Subject: Duke Energy Corporation  
Oconee Nuclear Station - Units 1, 2, and 3  
Docket Nos. 50-269, 50-270, and 50-287

Revisions to Topical Report DPC-NE-3003 In Support of  
Steam Generator Replacement  
Response to NRC Staff Request for Additional  
Information

Enclosed herein, please find the Duke Energy Corporation (Duke) response to the May 12, 2003 NRC staff's request for additional information concerning topical report DPC-NE-3003, Revision 1, "Mass and Energy Release and Containment Response Methodology."

### **Duke Power Response To Request For Additional Information**

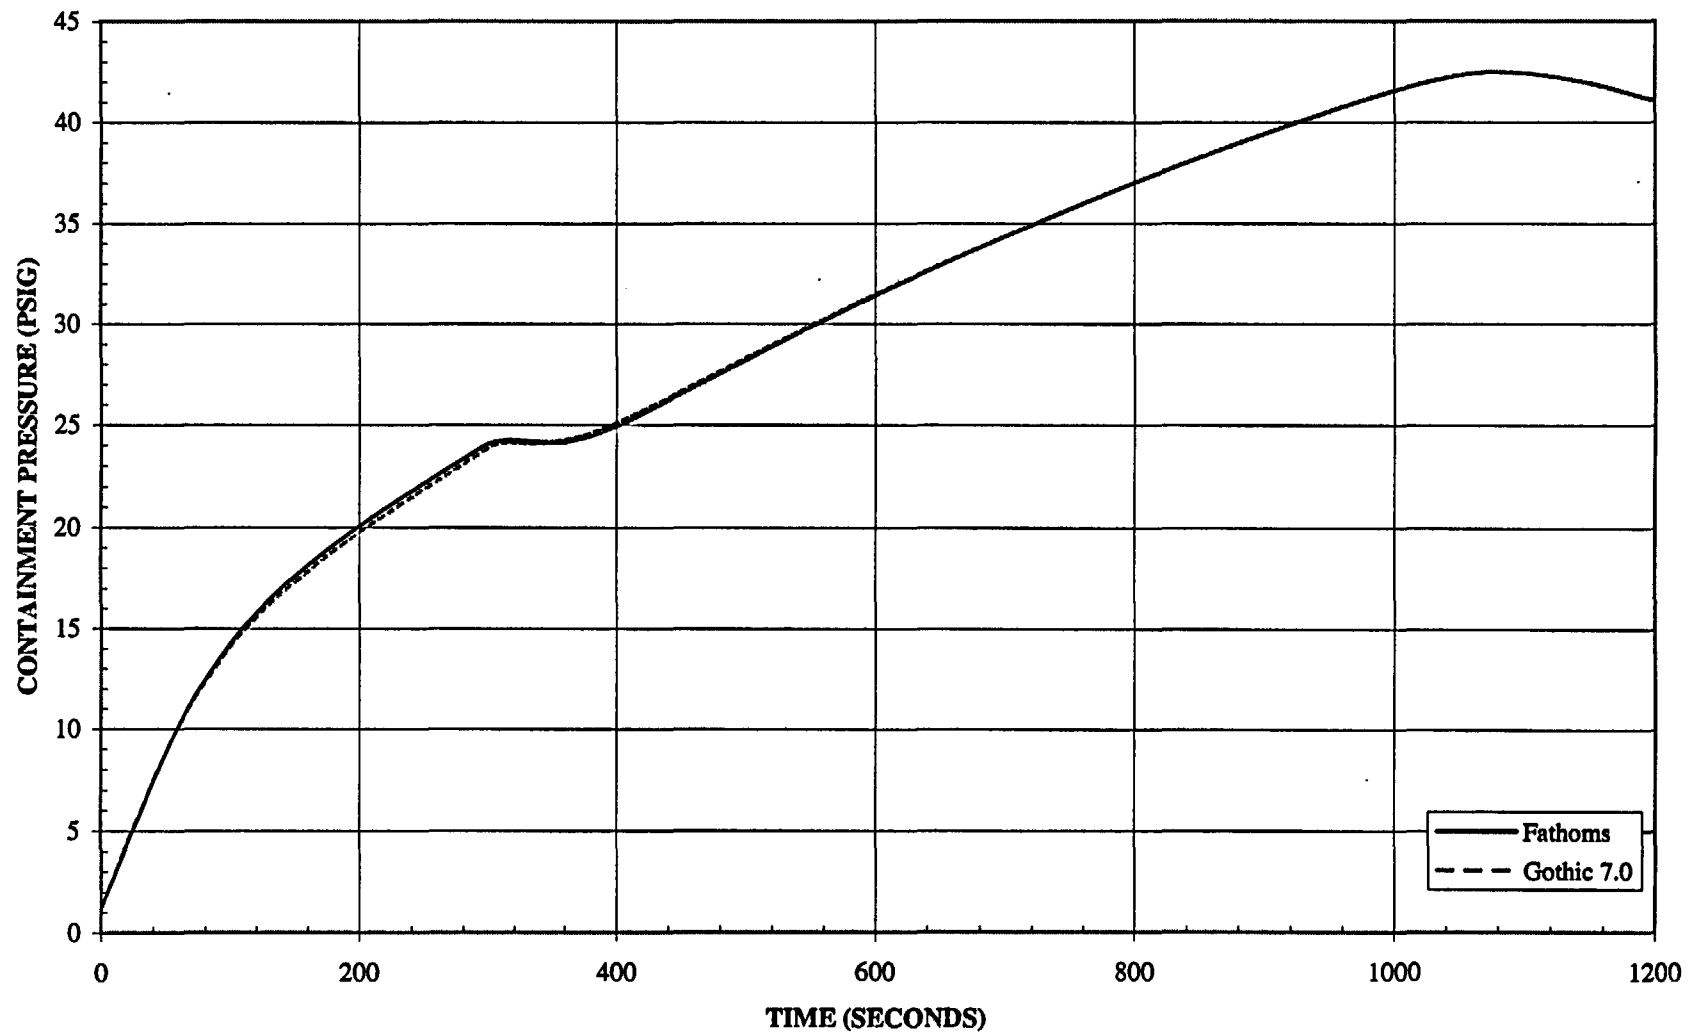
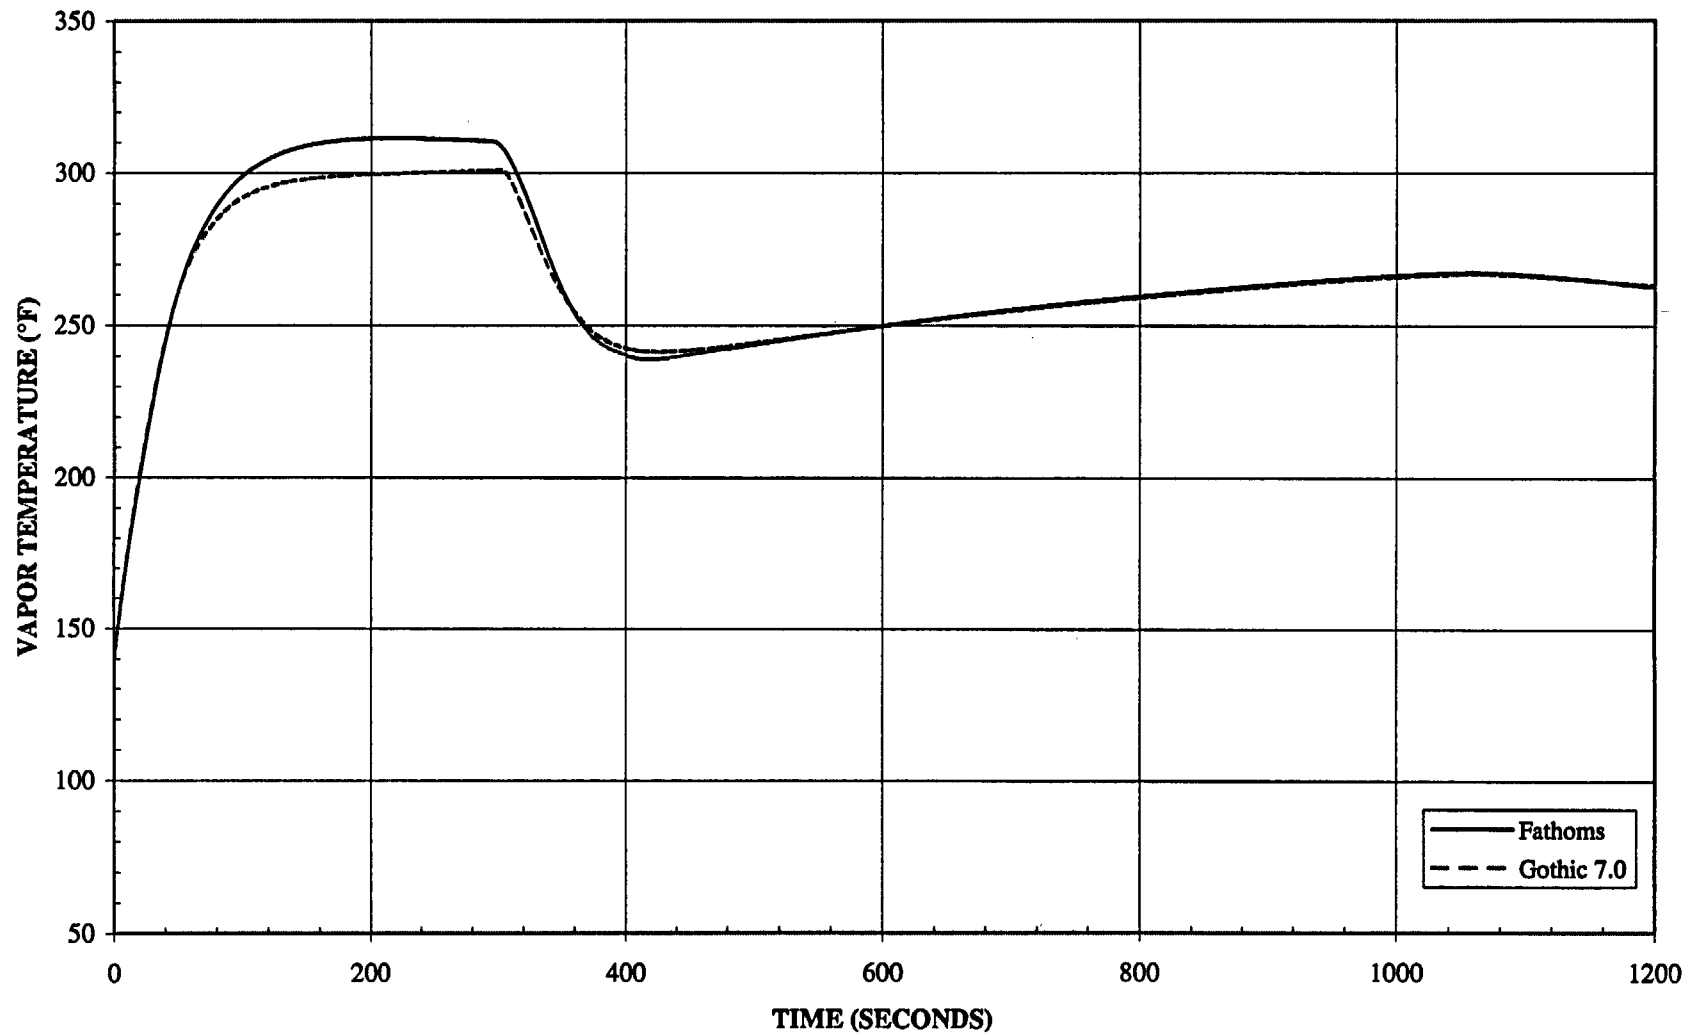
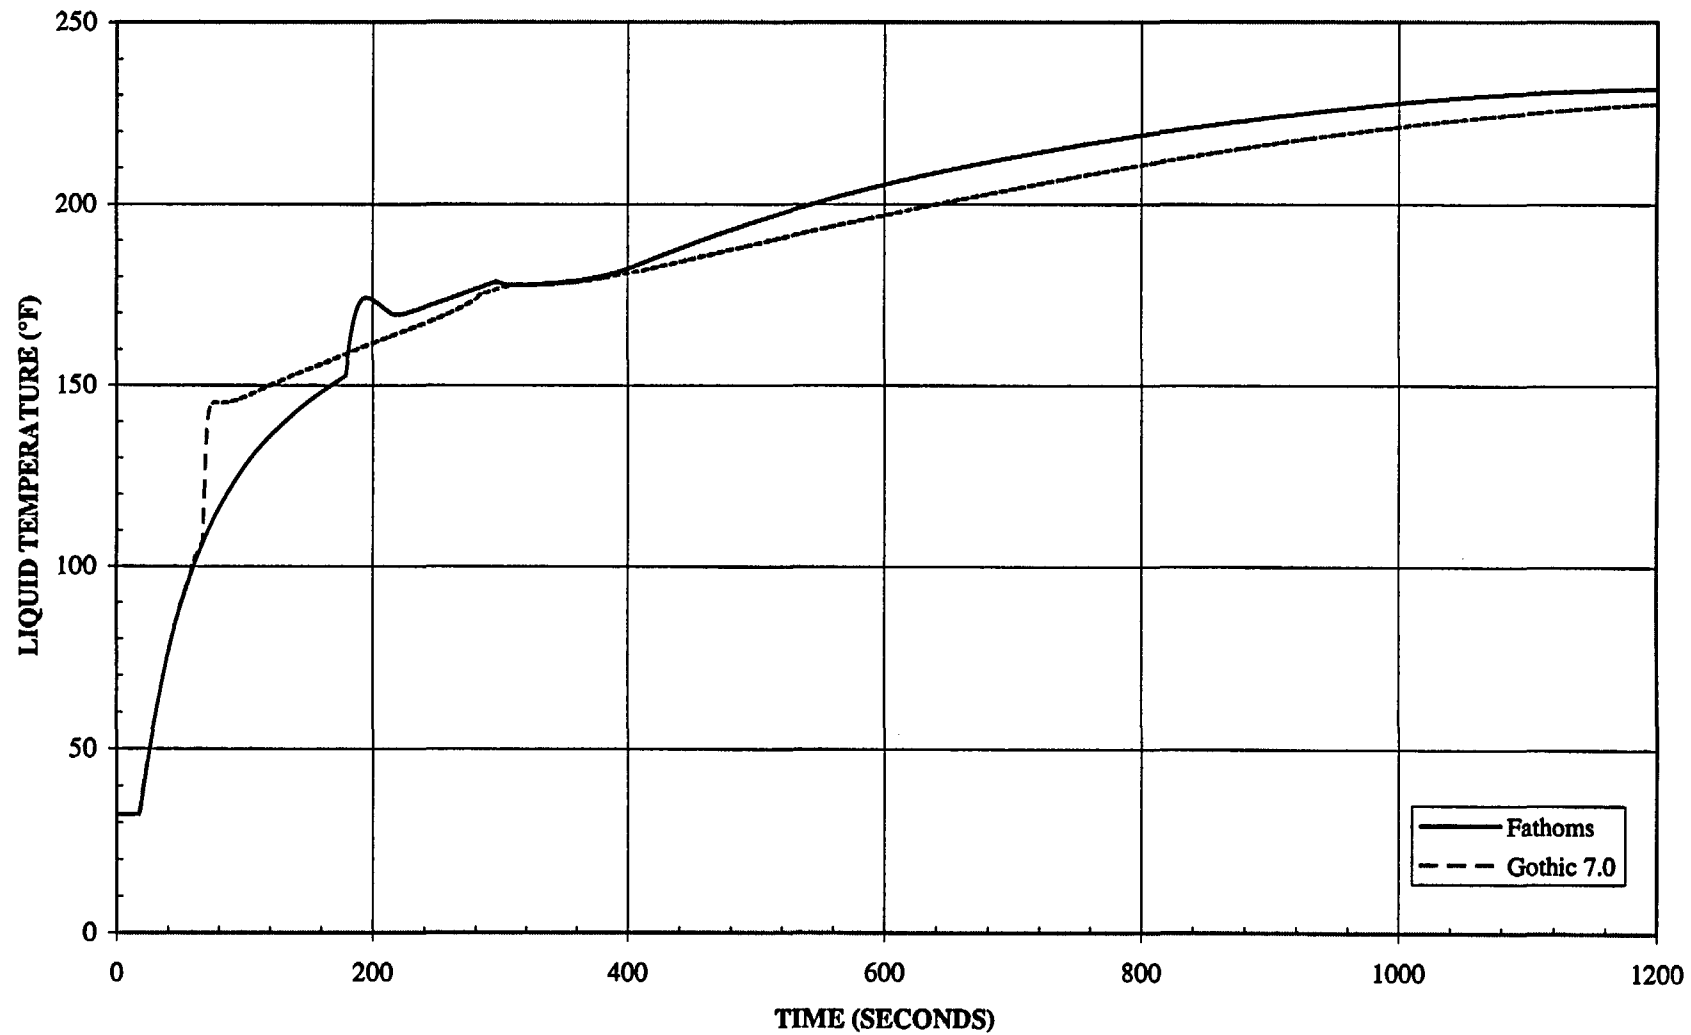
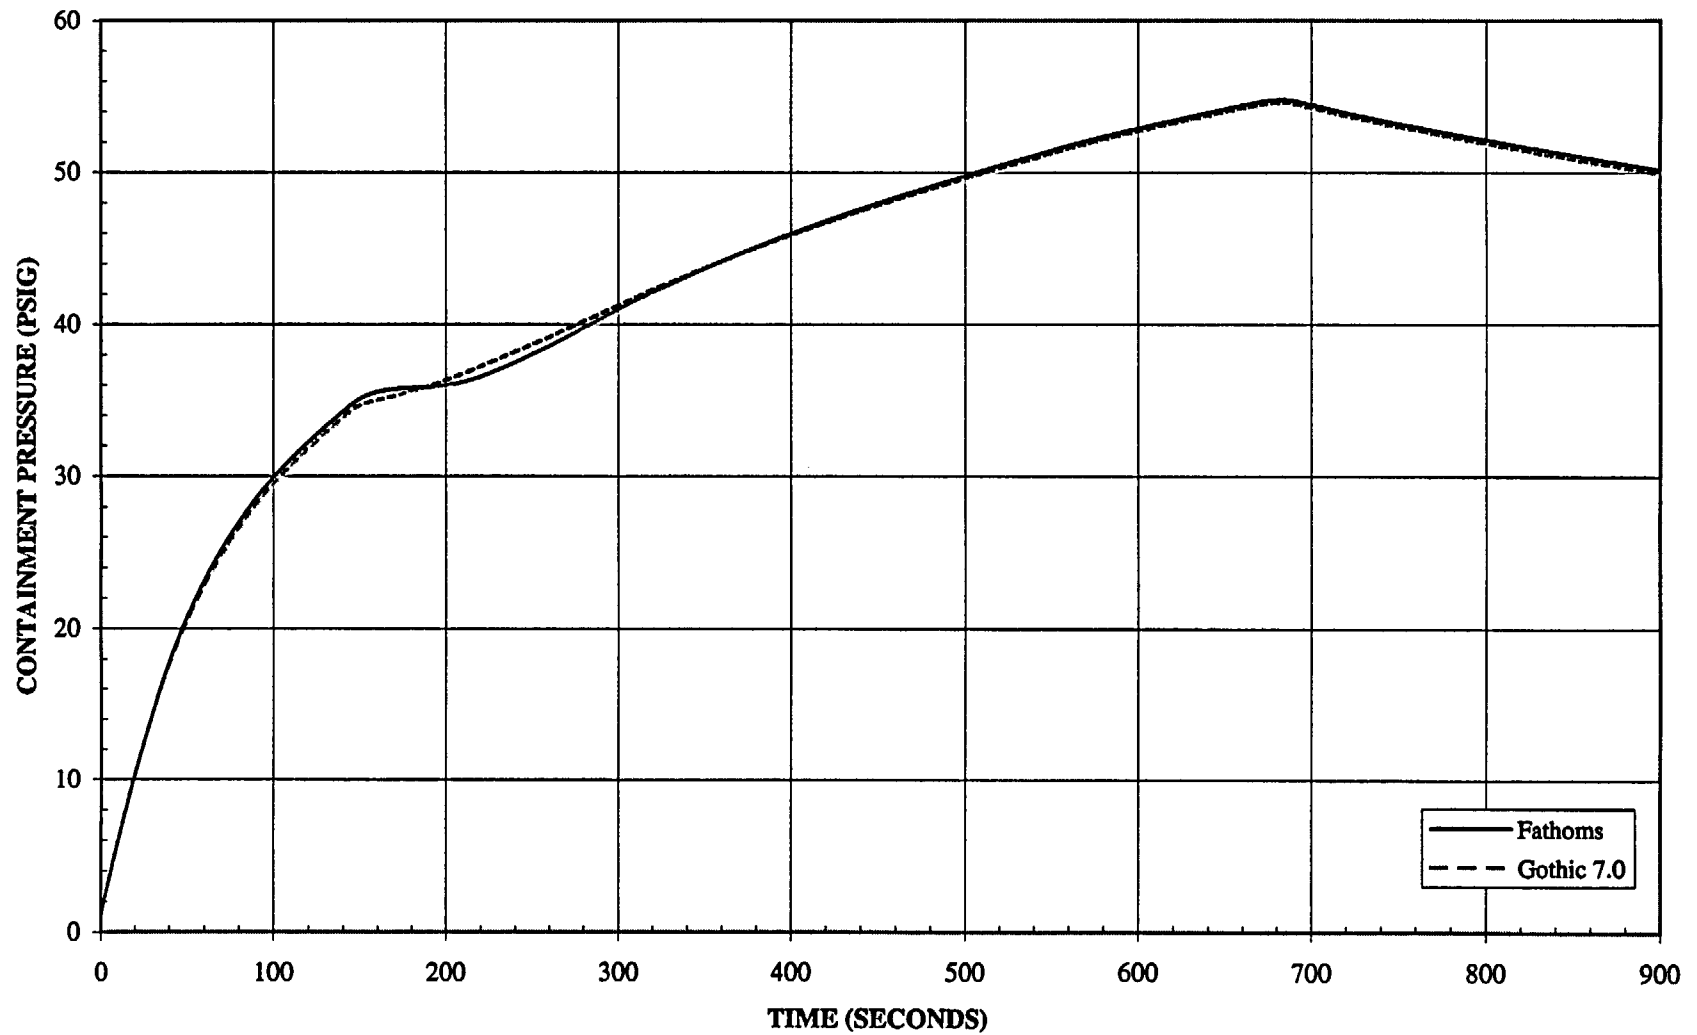
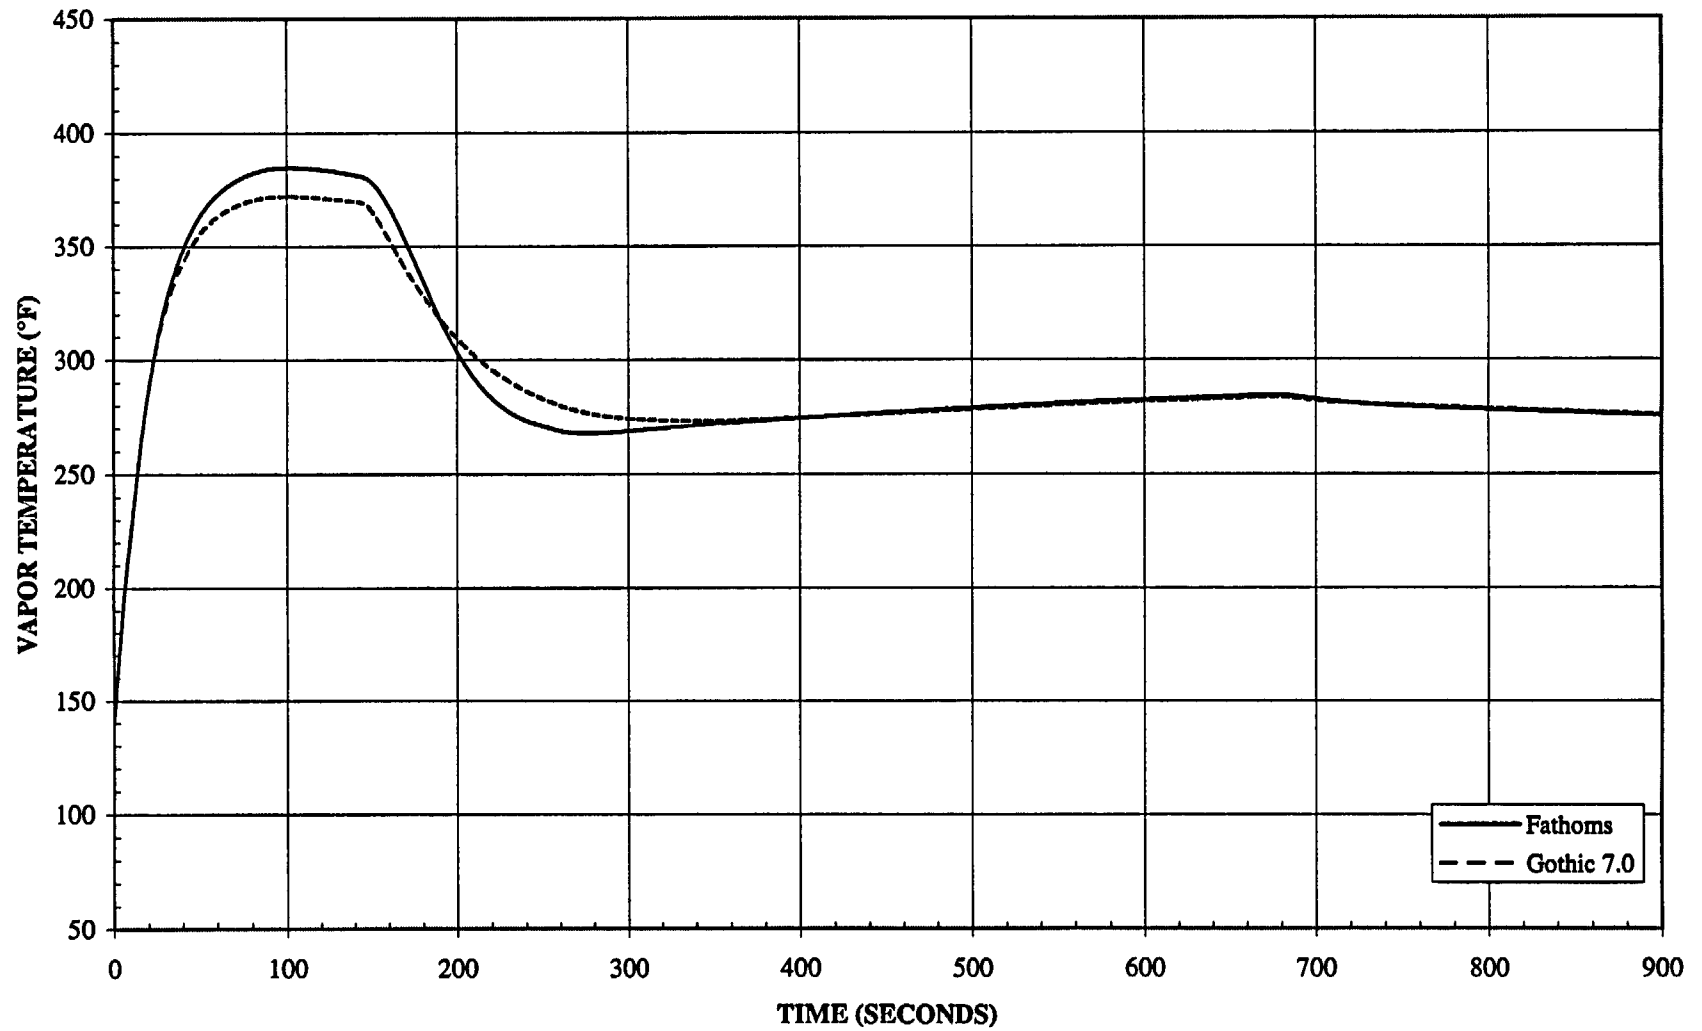
14. Show that GOTHIC and FATHOMS calculations result in the same pressures, temperatures, sump temperatures, etc. for the design basis LOCA and main steam line break events. If they do not, explain differences in terms of the differences in models between the two codes. (See Question 1.)

Response: Refer to the response to Question #3 for LOCA. The results of the 6 code comparison analyses for the main steam line break are given in Table 14-1 and the figures that follow. The containment response following a main steam line break event for the ROTSG was performed to compare the results from FATHOMS 2.4 and GOTHIC 7.0. In general, the pressure and vapor temperature responses are very similar. GOTHIC 7.0 predictions for peak pressures are slightly lower on the smaller break sizes (~0.3 psi) and slightly higher for larger break sizes (~0.95 psi). The peak vapor temperature responses predicted by GOTHIC 7.0 overall are slightly lower (~12°F). For larger break sizes, the higher pressure predicted by GOTHIC 7.0 may be attributed to additional steam generation from the improved interface heat and mass transfer models and from the drops that are generated due to dripping. The slightly lower pressure for smaller break sizes may be attributed to additional droplets in the atmosphere. The slightly lower vapor temperature and liquid temperature in GOTHIC 7.0 for all break sizes may be attributed to additional droplets in the atmosphere also. This effectively increases the heat capacity of the atmosphere and reduces the temperature rise for a given energy addition. As discussed in the responses to Questions #1 and #3, more liquid is predicted to remain in droplet form in GOTHIC 7.0 which results in less liquid mass in the sump. In addition, the lower sump temperature predicted by GOTHIC 7.0 may be attributed to the addition of the second energy equation for the drops and the improved heat and mass transfer models in GOTHIC 7.0.
